STARBUCKS
Lucan Retail Park

Starbucks, Lucan Retail Park, Lucan, Co. Dublin

Compliance Submission

Our Ref. 1677
Ref. No. SD21A/0323

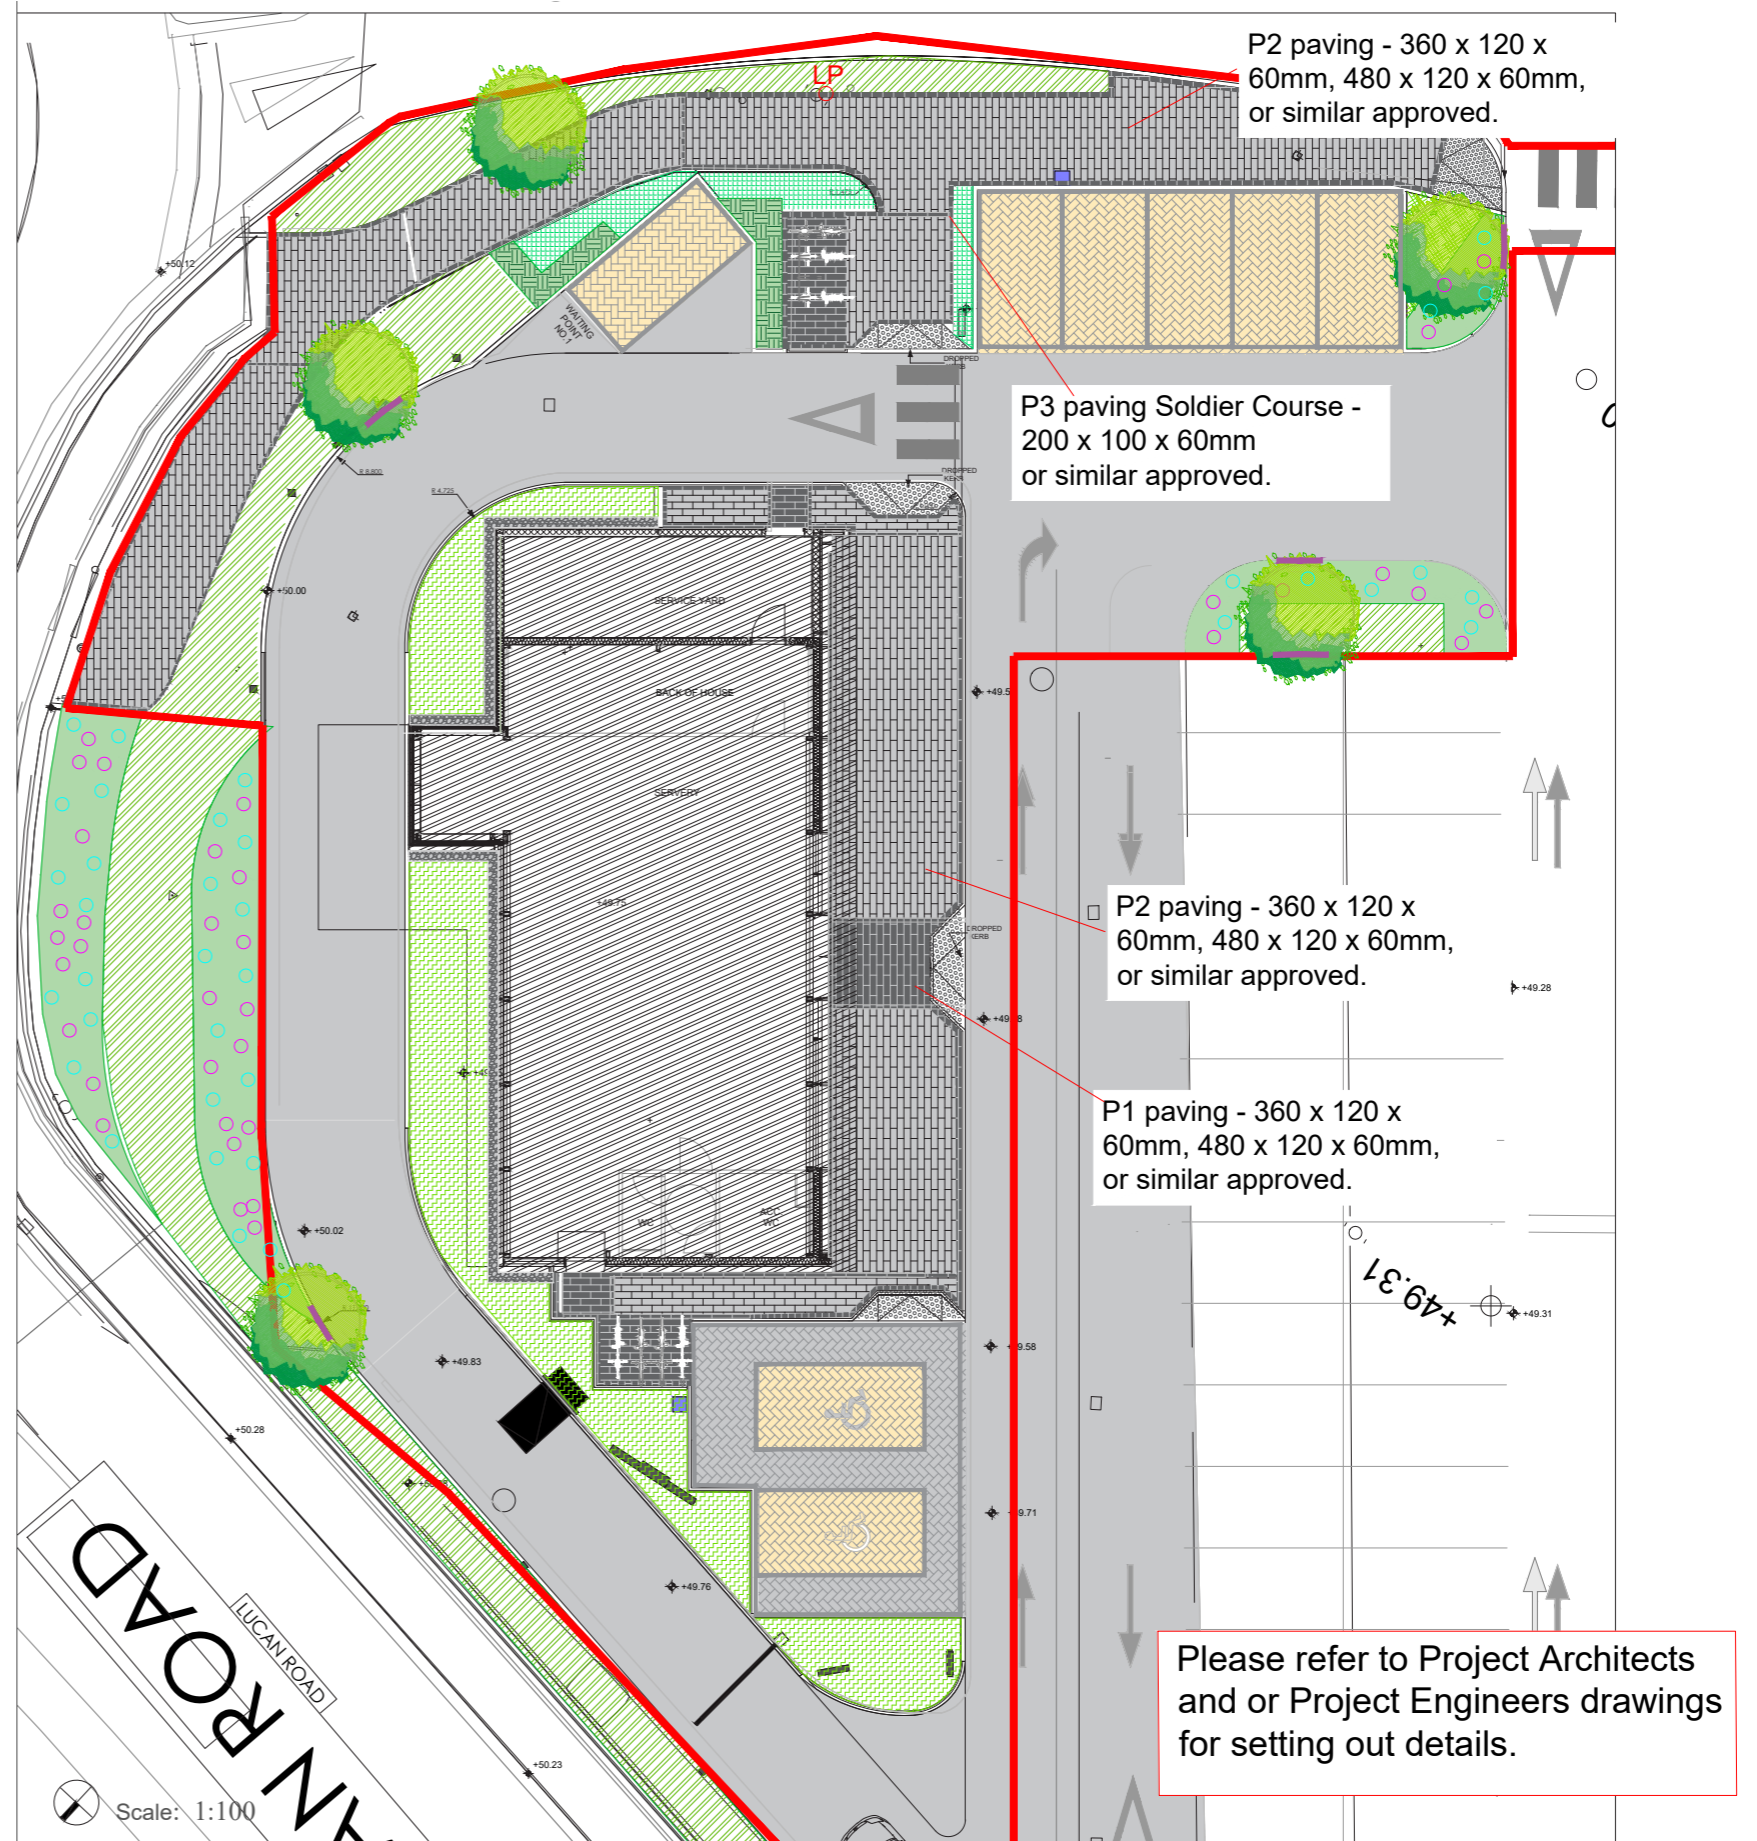
Request:

(i) a scaled plan showing all existing vegetation and landscape features to be retained and trees and plants to be planted;

Drawings to include;

(i) a scaled plan showing all existing vegetation and landscape features to be retained and trees and plants to be planted;

SOFT LANDSCAPE - or similar approved plants - subject to availability.	
	Proposed Tree Planting T1 - Carpinus betulus 'Frans Fontaine' 18-20cm
	- Prunus laurocerasus 'Zabeliana' (300-500mm high) 450mm topsoil depth

- Sarcococca hookeriana (300mm - 500mm high) 450mm topsoil depth
	- Buxus sempervirens (300mm - 500mm high) 450mm topsoil depth
	- Libertia grandiflora (300mm - 500mm high) 450mm topsoil depth

- Lavandula 'Hidcote'
	- Hedera helix Hibernica with bulbs: + Kniphofia royal standard 2L, Agapanthus 2L
HARD LANDSCAPE	
	Main Roadway Tarmacadam
	P1 - Paving - 360x120 x 60mm, 480x120x 60mm - Milan Midnight . Or similar approved
	P2 - Paving -360x120 x 60mm, 480x120 x 60mm - Silver Granite Or similar approved
	P3 - Paving - 200 x 100 x 60mm - Aqua Cobblesett Natural- Soldier Course. Or similar approved
	Car Parking - Hydropave Pedesta - Brindle with Natural On Edge Boundary To Engineer spec or similar approved
	Tactile Metal Blister Studs @ Crossings Steps and Ramps
	Dropped Kerb - Please see Engineer DWG for details
	Gravel Drain
	Bike Stands

Landscape Details -

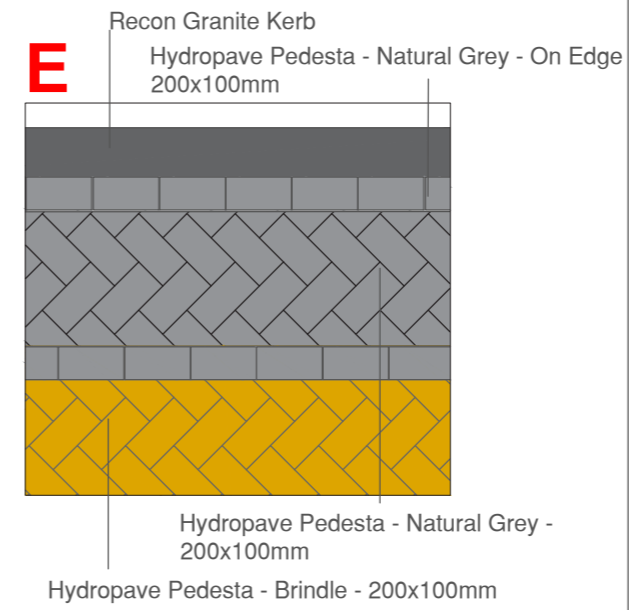
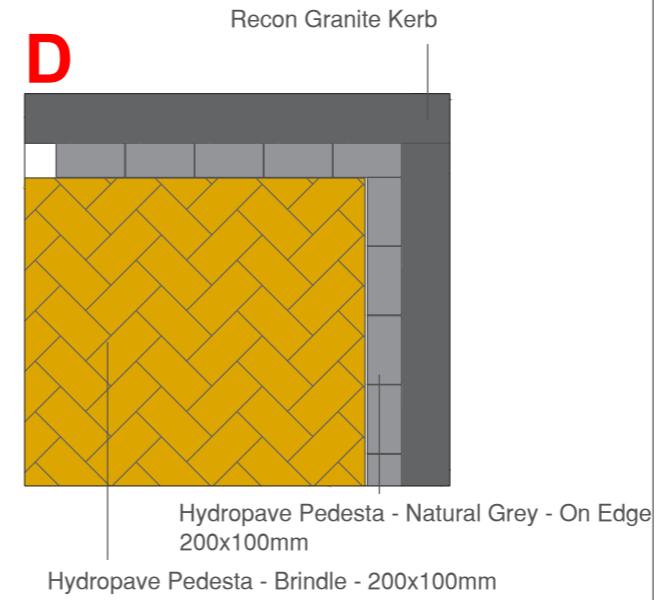
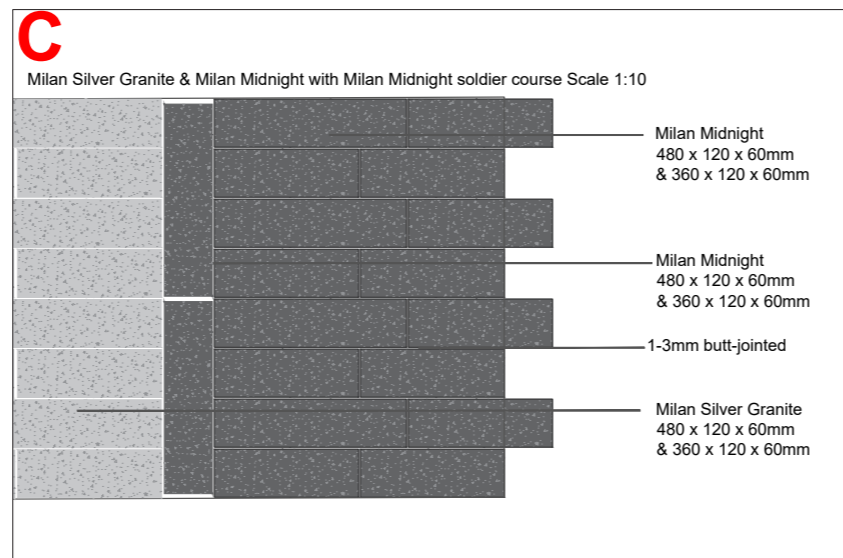
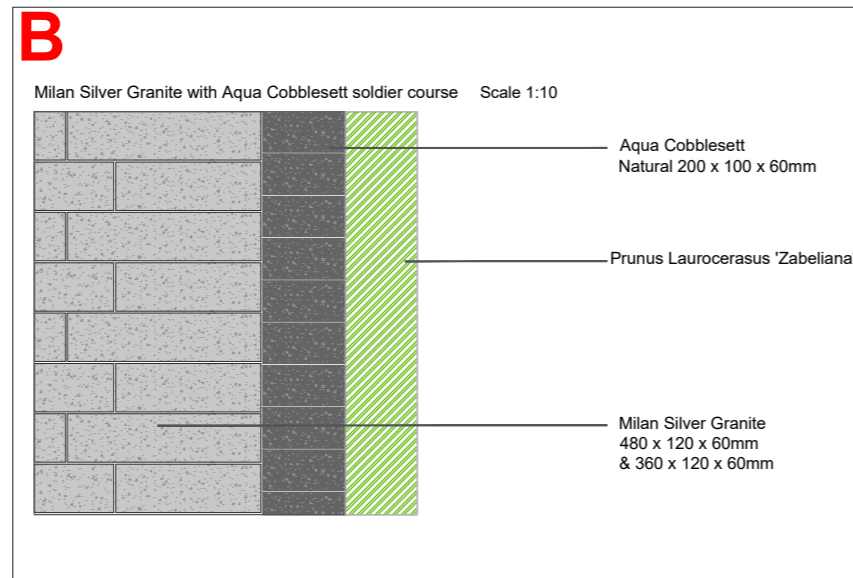
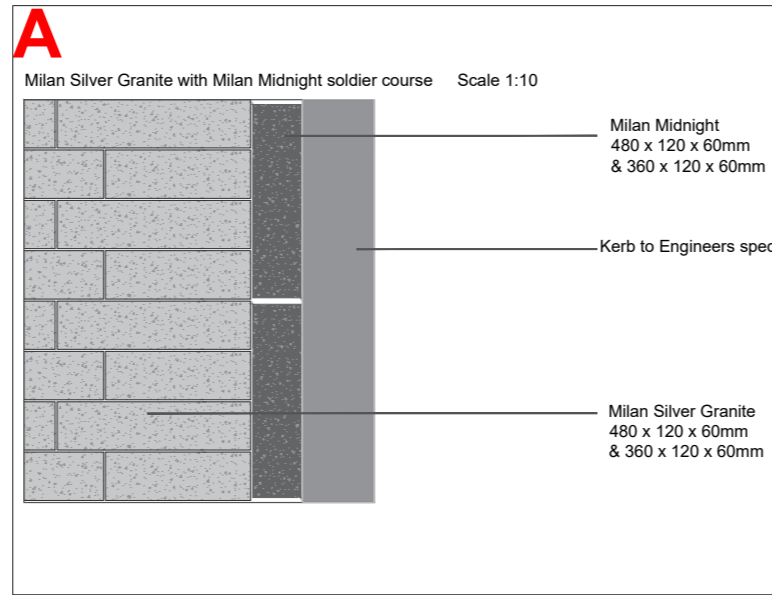
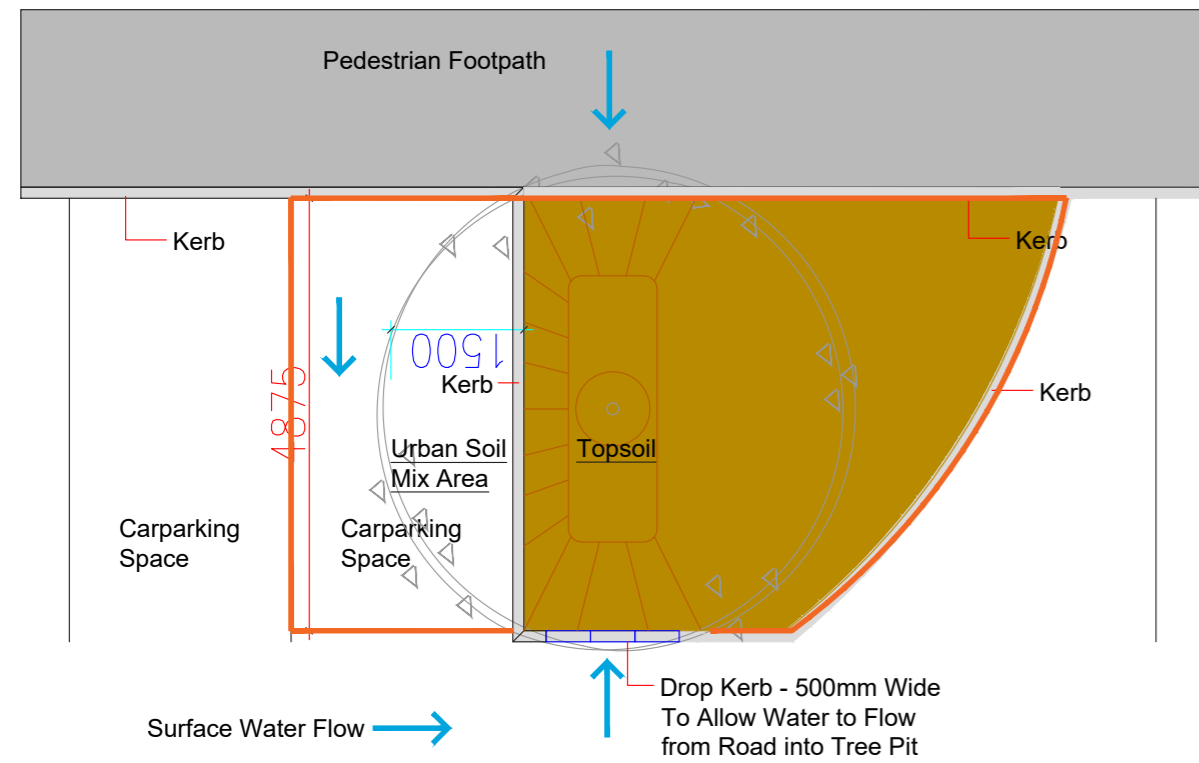
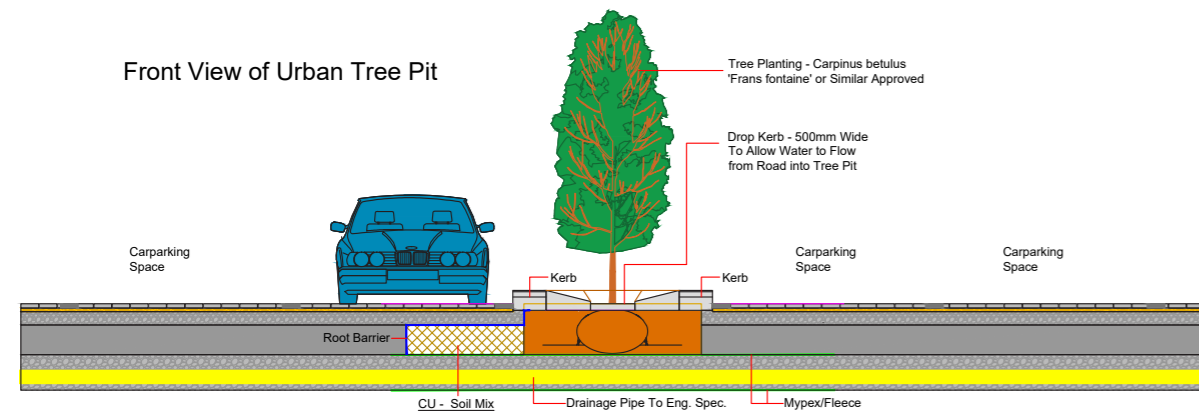
- (i) a scaled plan showing all existing vegetation and landscape features to be retained and trees and plants to be planted;
- (ii) location, type and materials to be used for hard landscaping including specifications, where applicable for: (a) permeable paving (b) tree pit design (to incorporate bioretention storage) (c) Sustainable urban drainage integration
- (iii) a schedule detailing sizes and numbers/densities of all proposed trees/plants;
- (iv) specifications for operations associated with plant establishment and maintenance that are compliant with best practice; and
- (v) types and dimensions of all boundary treatments

Tree Pit Location Plan, sc 1:100 @A3

Typical Plan View of Urban Soil Tree Pit -

Front View of Urban Tree Pit

Tree Pit Outline
